Propellers - Variable Pitch - Hartzell

**AD/PHZL/60**  
**Amdt 4**

**Three Bladed 'Y' Shank Aluminium Hubs**

**13/94**

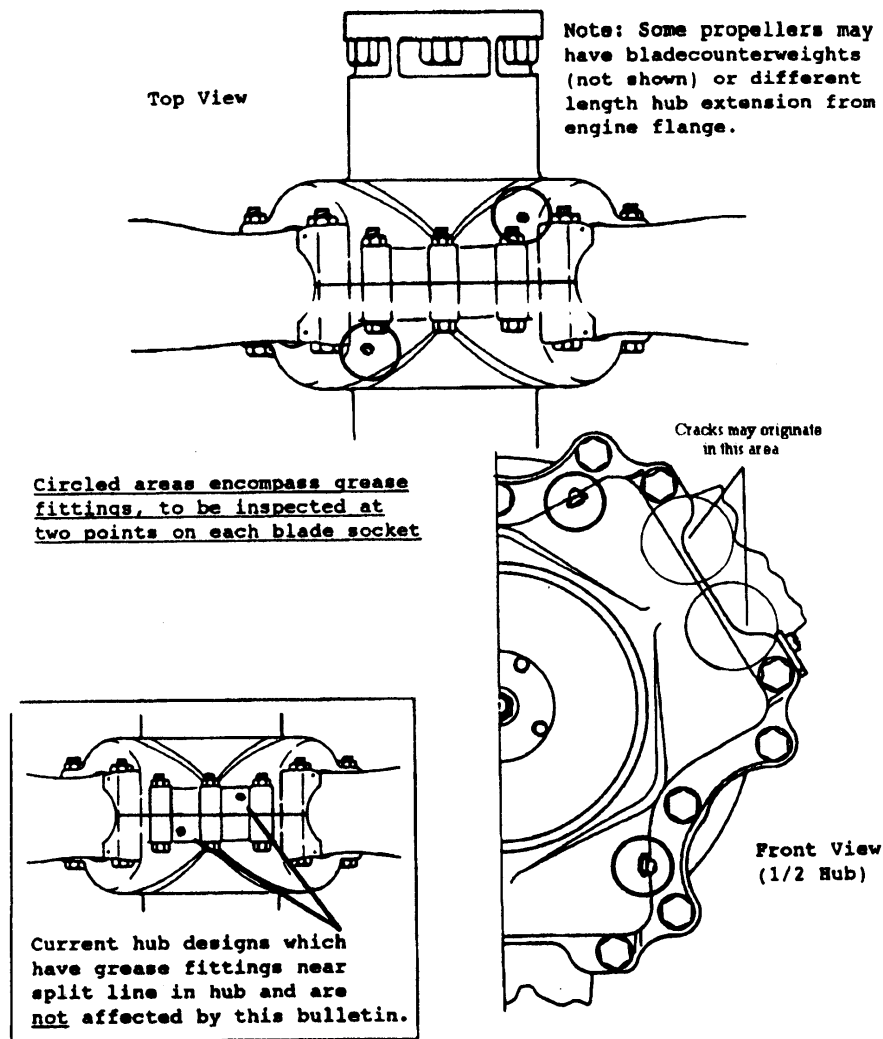
- Requirement:
1. Carry out a visual inspection of the hub using a 10X glass looking for signs of cracking or grease leakage. Replace any hub found cracked prior to further flight. Perform an eddy current or dye penetrant inspection in accordance with the procedures specified in Hartzell SB 165E on any of the above specified model and S/N propellers installed on any agricultural aircraft or Piper PA-31-325 Navajo C/R, Piper PA-31-350 Navajo “Chieftain”, Piper T-1020 (same as PA-31-350), PA-60-700P or Aerostar 700P aircraft.

2. For all other aircraft types listed in this Directive carry out a visual inspection of the hub using a 10X glass looking for signs of cracking or grease leakage. Replace any hub found cracked prior to further flight. Perform an eddy current or dye penetrant inspection IAW the procedures specified in Hartzell SB 165E.

3. For propellers installed on agricultural aircraft or Piper PA-31-325 Navajo C/R, Piper PA-31-350 Navajo “Chieftain”, Piper T-1020 (same as PA-31-350), PA-60-700P or Aerostar 700P aircraft, replace pre 1983 style hubs with post 1983 hubs. If during overhaul, post 1983 style hubs are not available and the hub passes overhaul requirements then, the pre 1983 hub chamfer modification in accordance with Procedure 2 of Hartzell SB 165E may be incorporated. Hubs so modified are exempt from Requirements 1 and 2 of this Directive.

4. For all other aircraft types listed in this directive, replace pre 1983 style hubs with post 1983 hubs. If during overhaul post 1983 style hubs are not available, and the hub meets overhaul requirements then, the pre 1983 hub chamfer modification in accordance with Procedure 2 of Hartzell SB 165E may be incorporated in a serviceable pre 1983 hub. Modified hubs are exempt from Requirements 1 and 2 of this Directive.
